Parramatta Powerhouse EIS

Flood Risk Review

Powerhouse Museum Alliance

Molino Stewart Pty Ltd

Figure 7: Proposed Arrangements for Managing Overland Flows

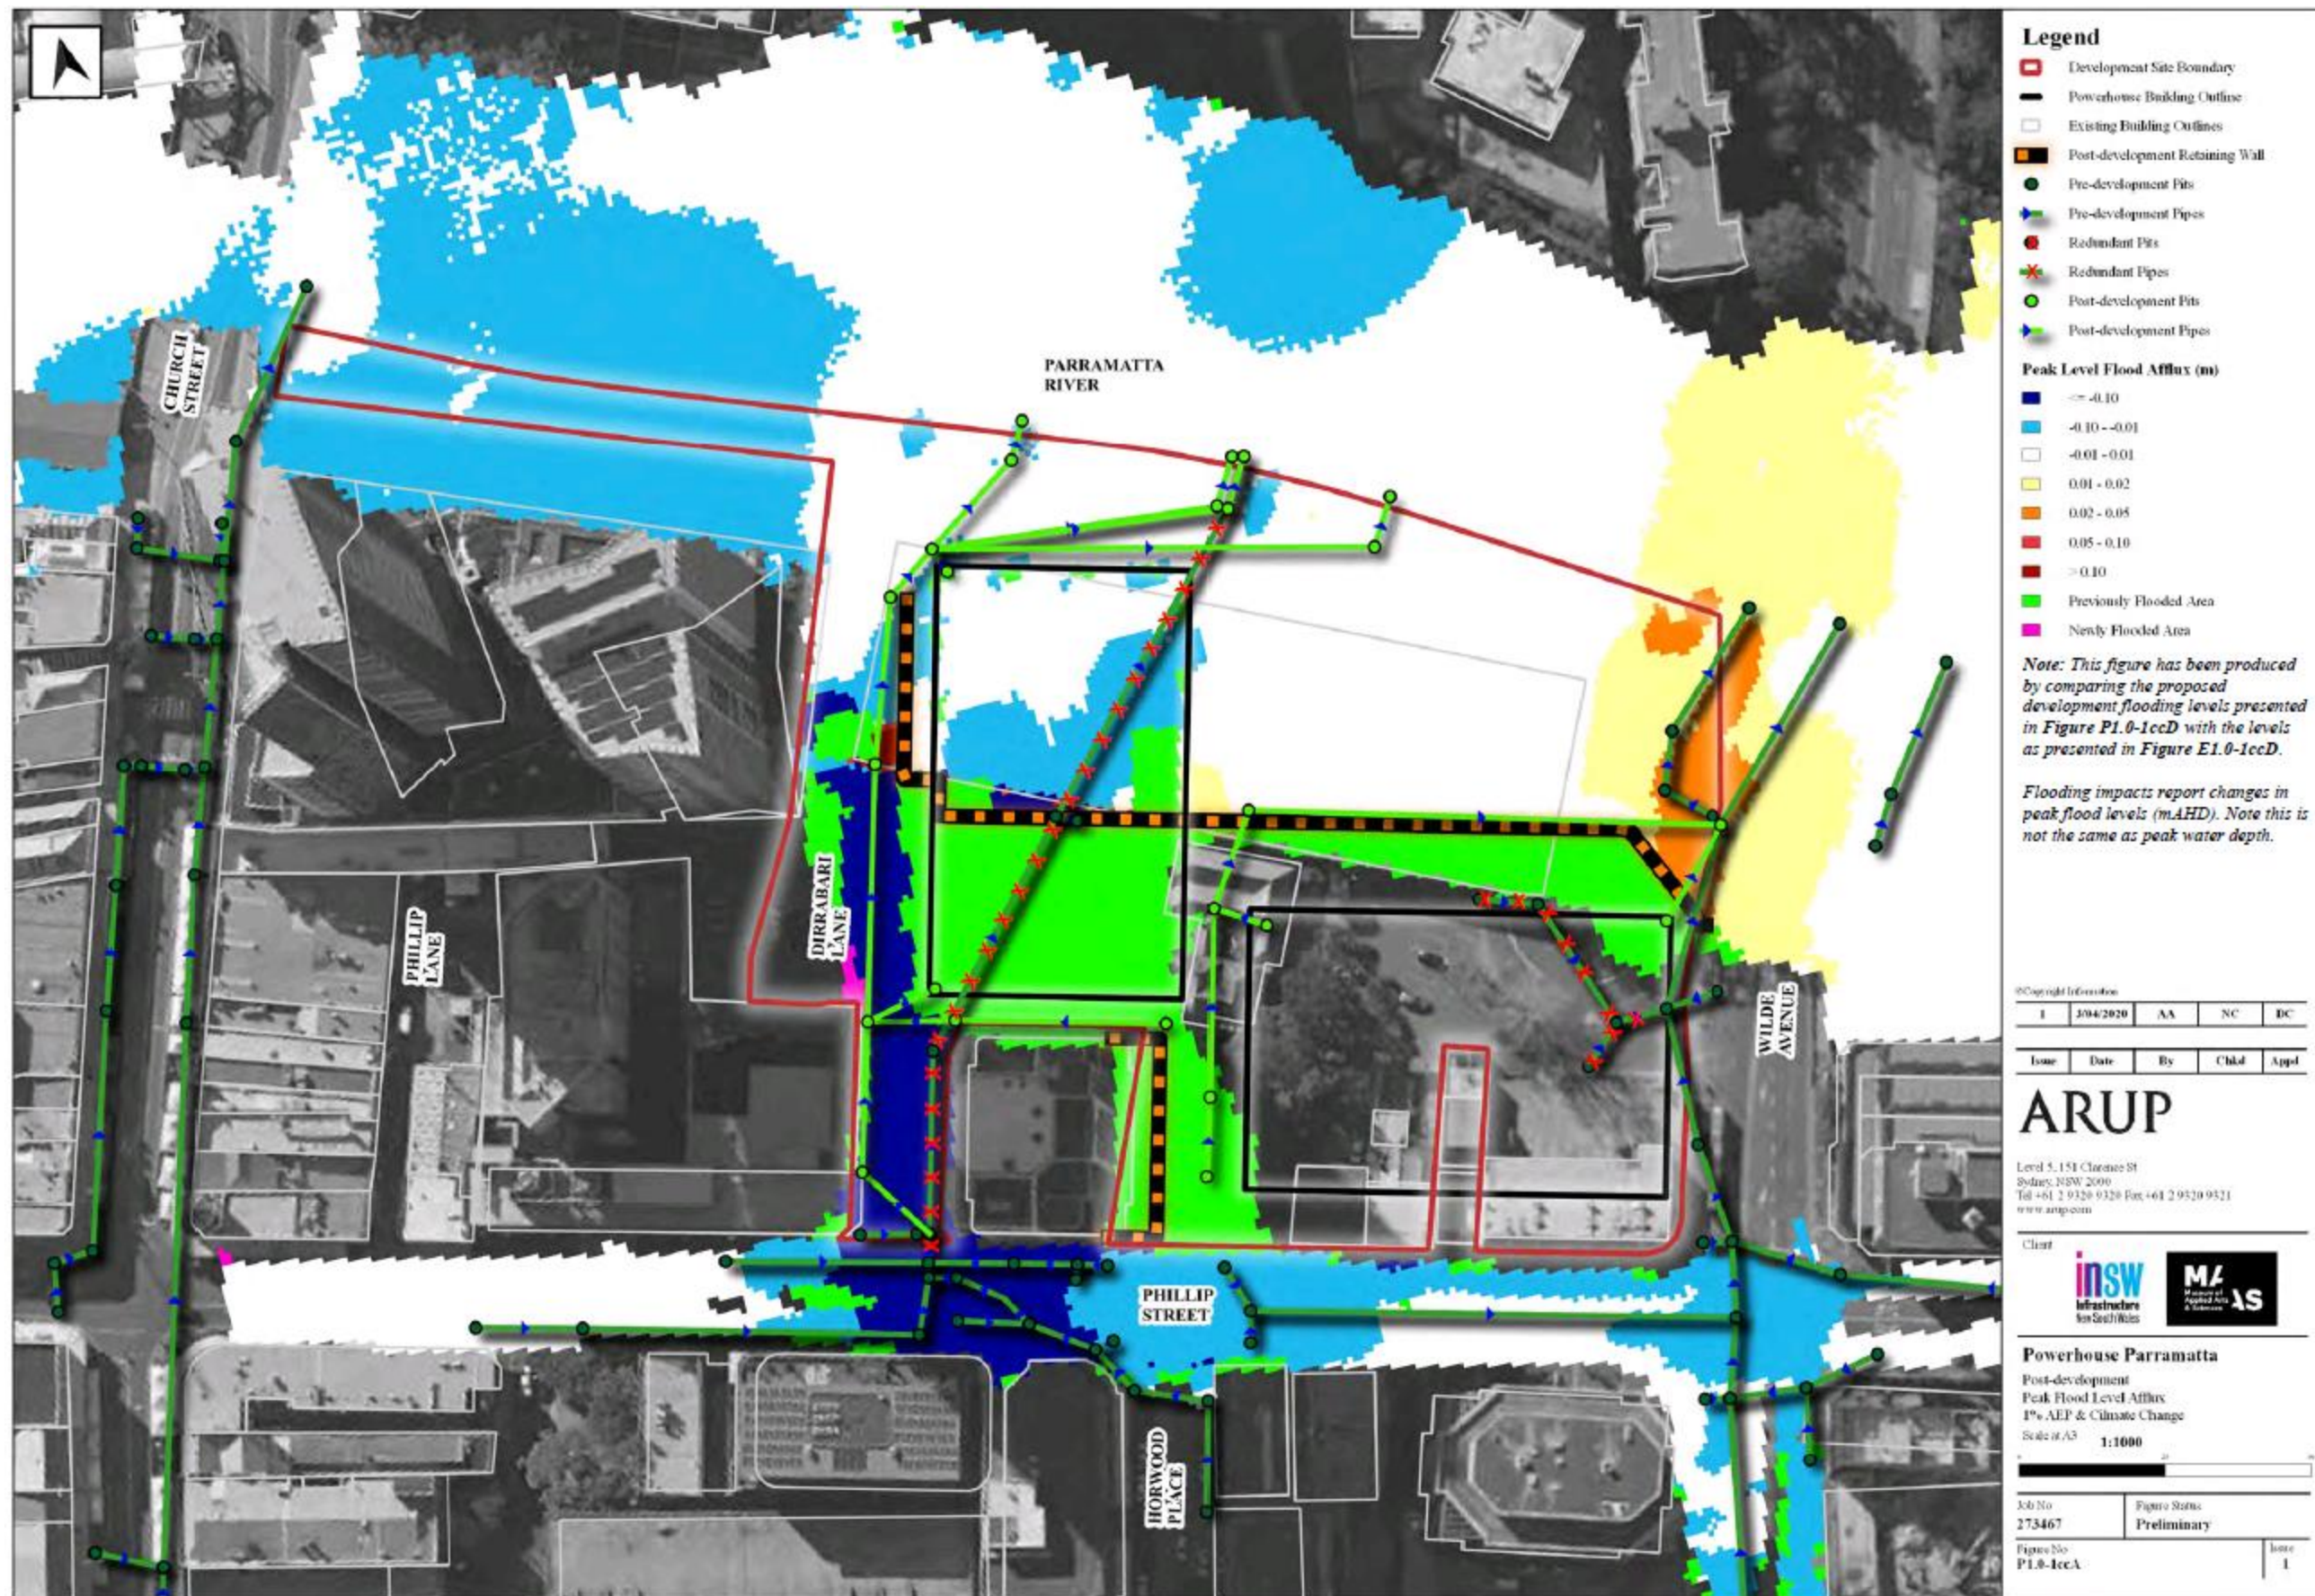
The problem this creates is that it effectively raises the overflow points that flows in Phillip Street currently rely upon to reach the river. To prevent the water ponding to greater depths in Phillip Street, the design response has been to provide more and larger underground pipes to convey water from Phillip Street to the River and to provide better defined overland flow paths between Phillip Street and the River as shown in Figure 7.

This solution itself has two problems.

The first is that it relies upon the inlets to the pipes and the pipes themselves remaining unblocked. Although Appendix O says that the modelling was undertaken with an appropriate amount of assumed pipe blockage, it does not stipulate what that amount was. It is therefore difficult to determine whether the proposed solution can be relied upon to achieve its

objective of not making flooding worse for neighbouring properties. This is another requirement of the Parramatta DCP.

Figure 8: Pedestrian Connections

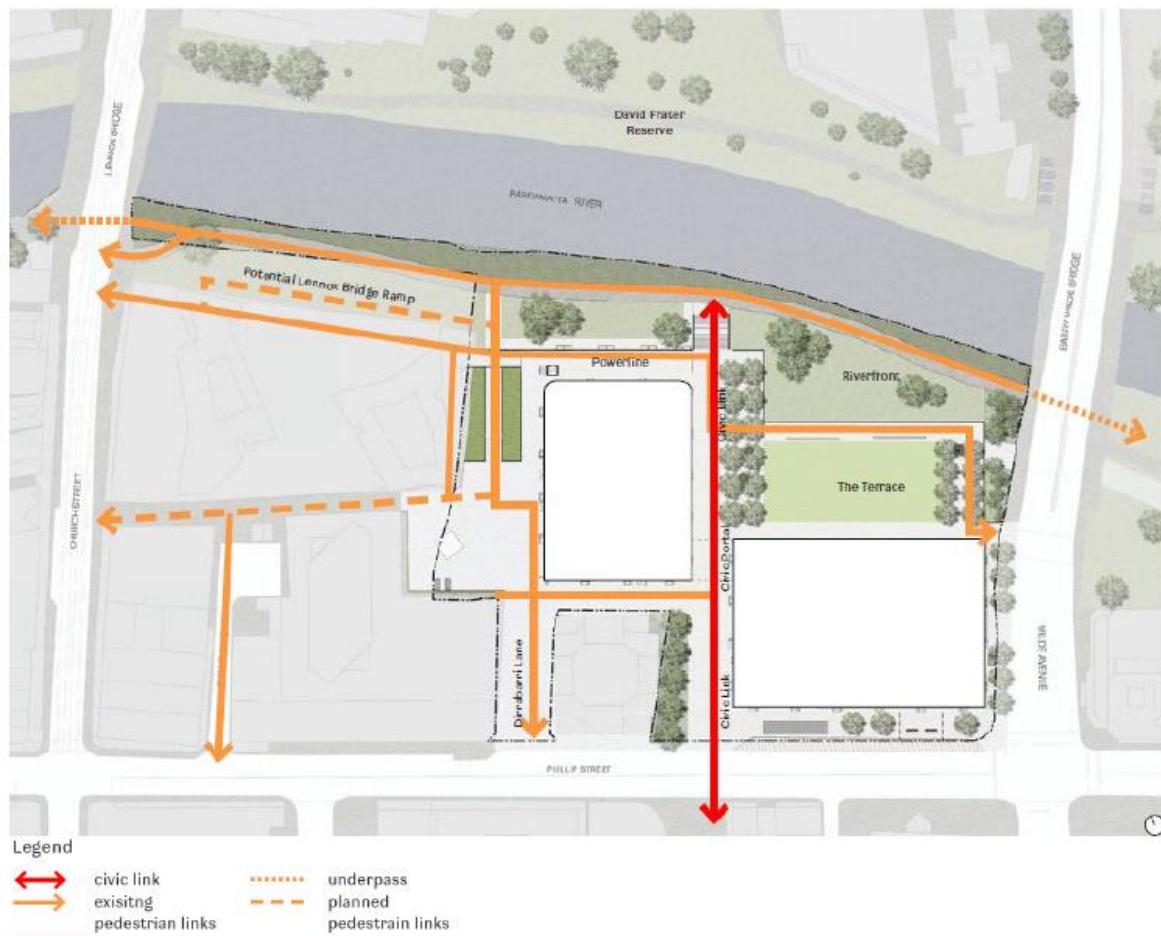
The second problem this presents is that it directs the overland flows along designated pedestrian connections between the river and Phillip Street (Figure 8). This means that should people by the riverside need to evacuate to escape a rising river, they may be confronted by a torrent cascade cascading down each of their possible escape routes.

This is an unacceptable design solution, particularly when considering that some of the evacuees may be children, people with walking aids (e.g. wheelchairs), and families with prams. According to the flood hazard classification proposed by Smith et al. (2014) and adopted in the Australian Rainfall and Runoff Guidelines (Ball et al., 2019), children and elderly people are at risk of life when exposed to floodwaters as shallow as 0.5m, or even lower depths if flow velocity is in excess of about 1m/s (which is common along overland flow paths). There are no specific thresholds for people in wheelchairs and prams, but it is likely that these groups would be at risk at even lower values of depth and velocity.

Furthermore, the overland flow path down Dirrabarri Lane is also the designated emergency vehicle access.

While it is acknowledged that there is already some overland flow down existing pedestrian links, the development should mitigate this risk rather than exacerbate it.

Figure 9: Flood Evacuation Assessment

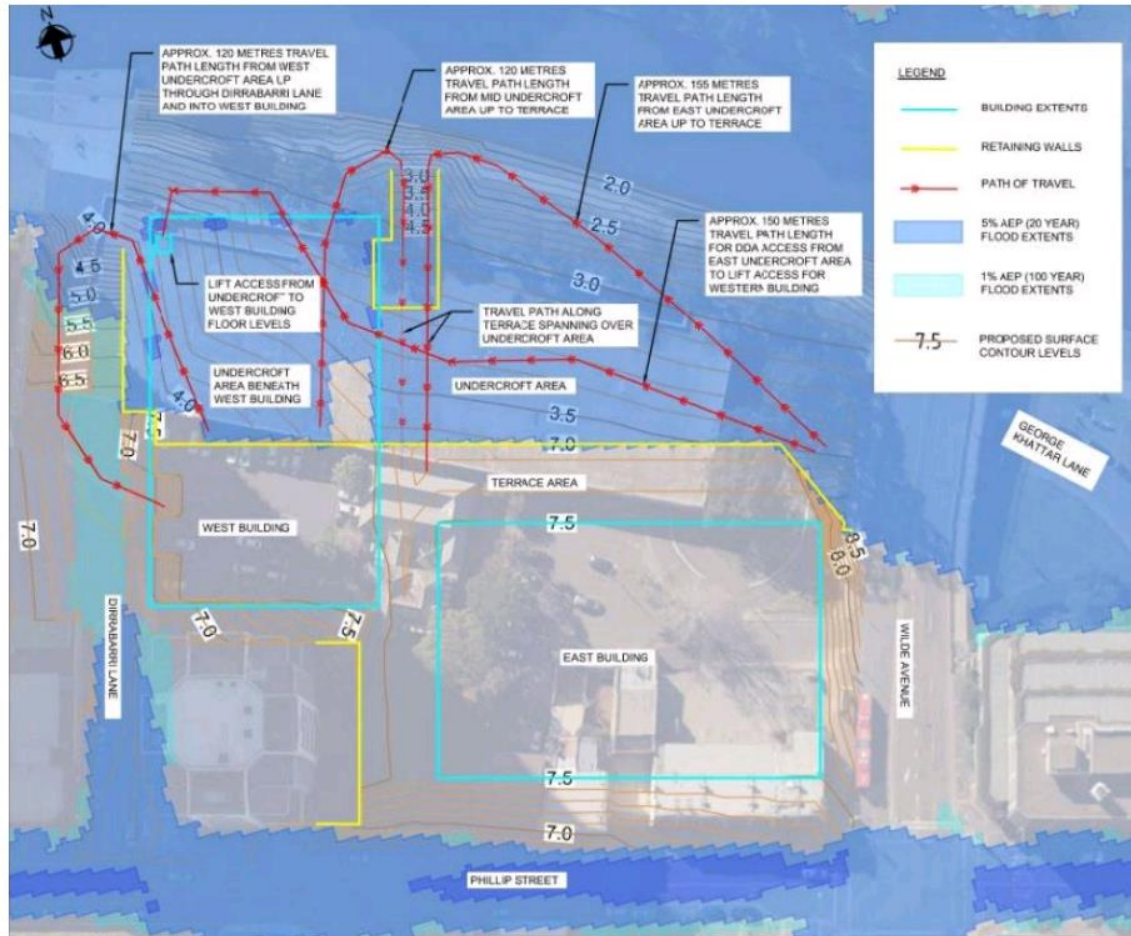
It is quite reasonable to expect that during inclement weather, museum patrons, or more likely, members of the public could take shelter in the undercroft areas. However, as shown in Figure 9, there are two problems in leaving these shelters once flooding commences.

The first is that it is necessary to walk down towards the river before being able to walk up to flood free ground.

The second is that the routes up are designed as overland flow paths.

People sheltering within these spaces may not appreciate just how high and how quickly the river can rise and they become entrapments in which people drown or they drown trying to leave them.
